**CITY OF SACRAMENTO
DEPARTMENT OF PLANNING & DEVELOPMENT
ZONING ADMINISTRATOR
1231 I Street, Sacramento, CA 95814**

ACTION OF THE ZONING ADMINISTRATOR

On Tuesday, February 7, 1995, the Zoning Administrator approved with conditions a Special Permit for Deep Lot Development to construct two units for the project known as Z94-101. Findings of Fact and conditions of approval for the project are listed on pages 3-6.

Request: Zoning Administrator's Special Permit for Deep Lot Development for three single family detached units on 0.33± vacant acres in the Standard Single Family (R-1) zone.

EXHIBIT - B

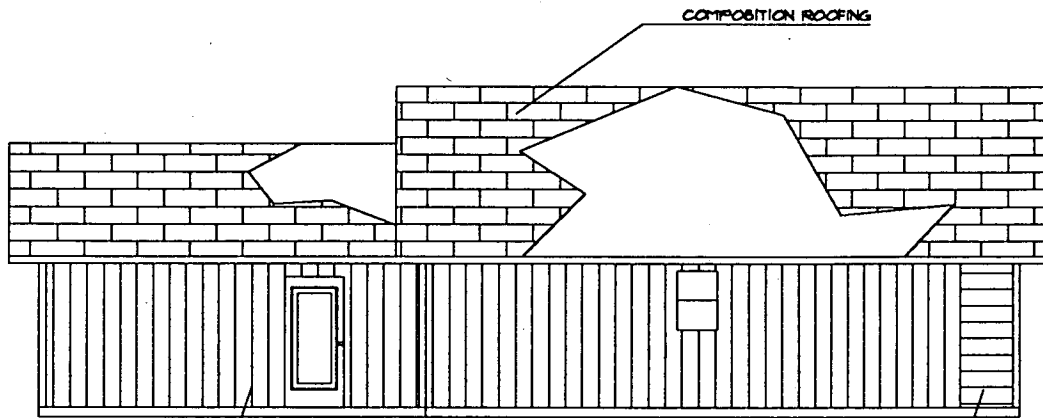
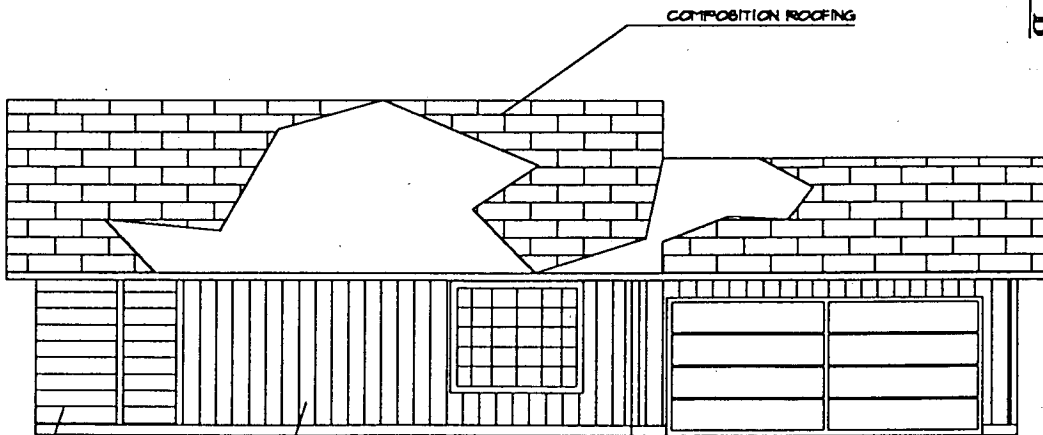
- h. all east elevations shall have horizontal lap siding and the north elevations for the front unit shall have horizontal lap siding;
 - i. a six foot wood fence shall be provided along the north and south property lines from the front setback to the rear of the property and across the rear (west) property line and in the southwest corner of the front unit. A fence shall also be provided between the units to provide private yard area (this fence does not need to be six feet in height). All fencing shall meet the Zoning Ordinance requirements; specifically, no solid fence or chain link fence taller than three feet in the front setback area or higher than six feet any where else. If a gate is installed across the driveway, it shall be setback a minimum of 20 feet from the east property line per City Code. {Fencing shall be installed prior to Final Inspection};

- m. add louvered shutters to both windows on east elevation;
- n. create a slight projection of the gable (a few inches beyond the main wall) on the east elevation;
- o. use 30 year laminated dimension composition shingles;
- p. create a porch element (talk to Randy Lum at 264-5896);

EXHIBIT F

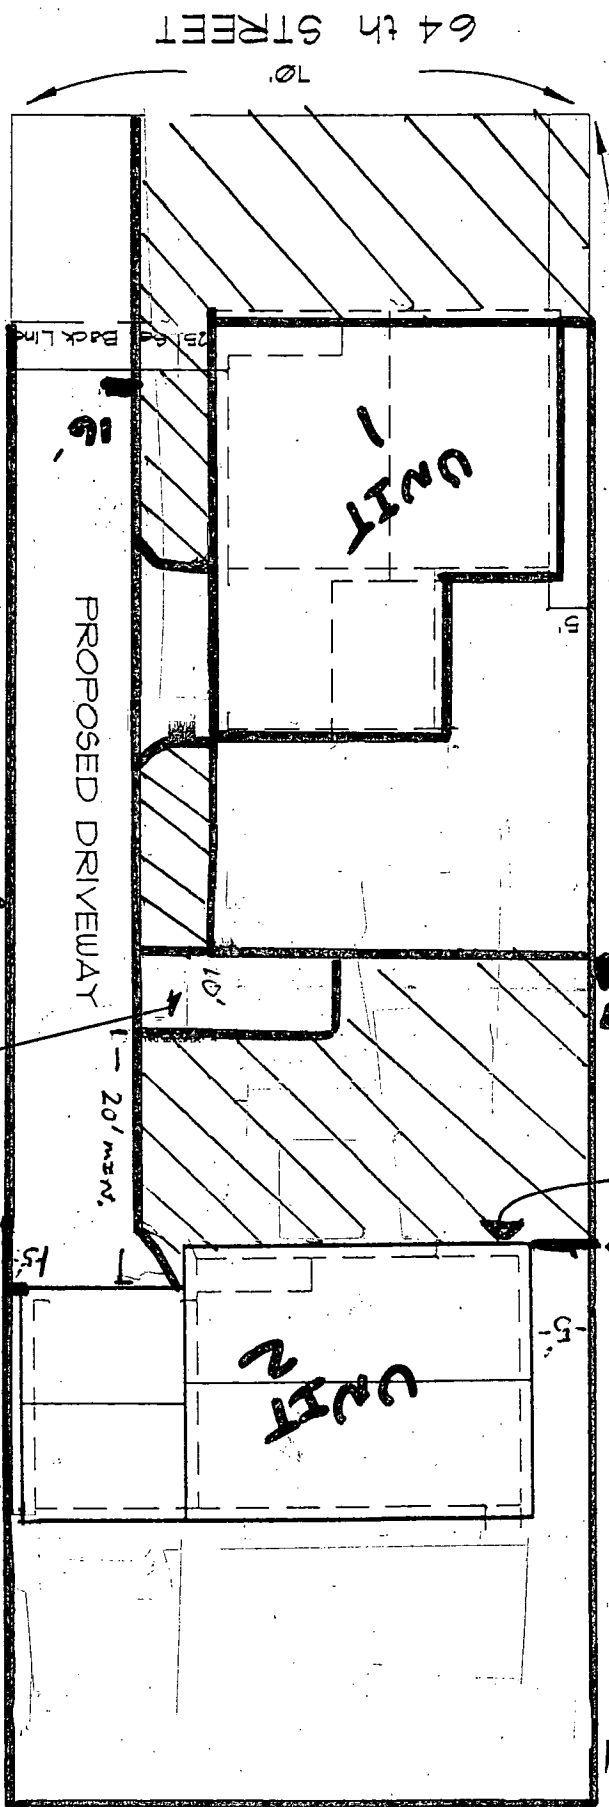
- j. there shall be no parking of vehicles, dumping, or non-enclosed storage on the vacant rear section of the lot;
 - k. the front area of each unit shall be landscaped with sod, shrubs, at least one tree, and irrigated with an automatic sprinkler system (see Staff Exhibit F);

- q. use the proposed third unit floor plan;
 - r. revise the site plan to relocate the second unit further back (at least 20 feet) from the centerline of the property {123 feet from the front property line minimum};

- s. provide a turn around maneuvering pad out of turf block located a minimum of 10 feet from the front of the second unit;
 - t. revise the south elevation to include eliminating the rear door from the house, relocate the dining room window to the kitchen area, and provide a sliding glass door in the location of the dining room window;

Unit 2
Minimum 123 feet
from front property
line

EXHIBIT H

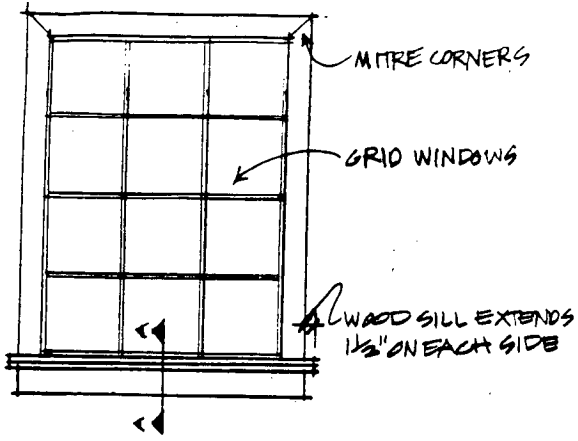
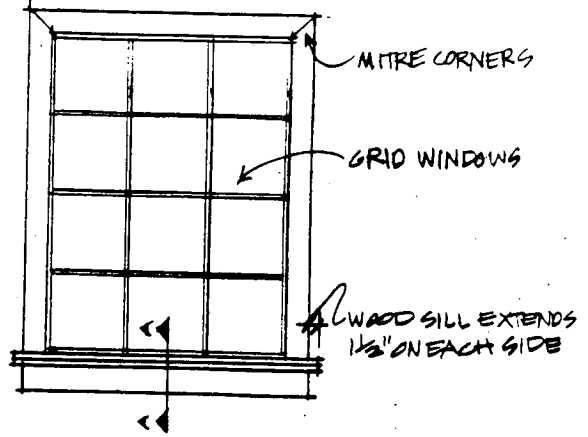
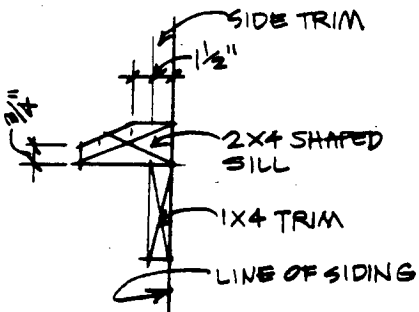
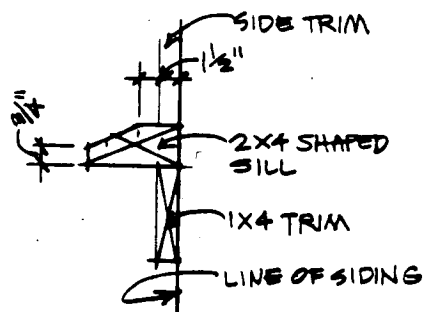
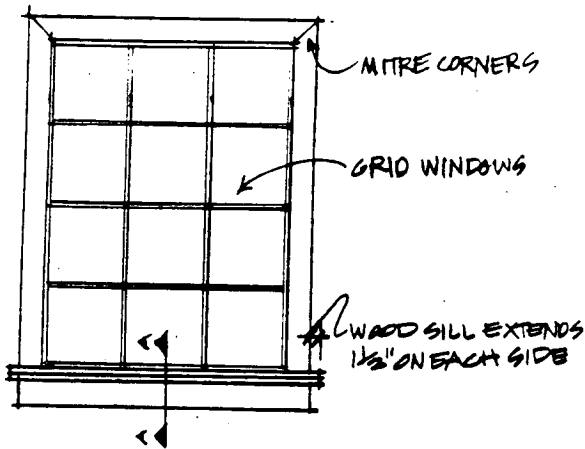
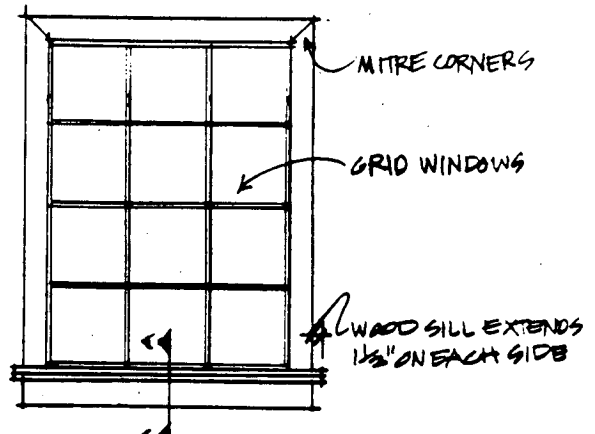
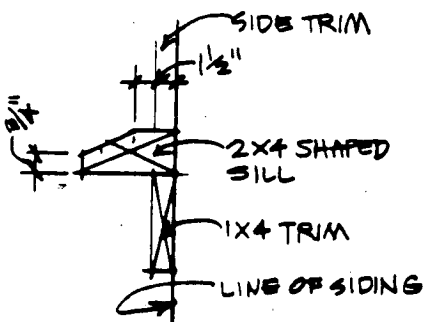
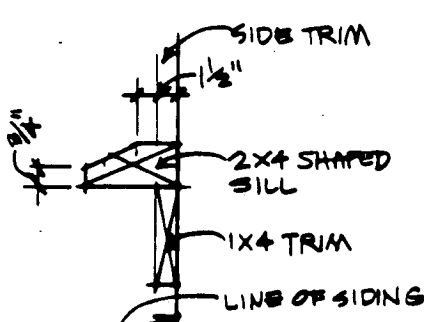
- c. all garage doors shall be metal sectional doors subject to Planning staff review;
 - d. all windows shall have the window treatment as indicated by Design Review (see Staff Exhibit H);
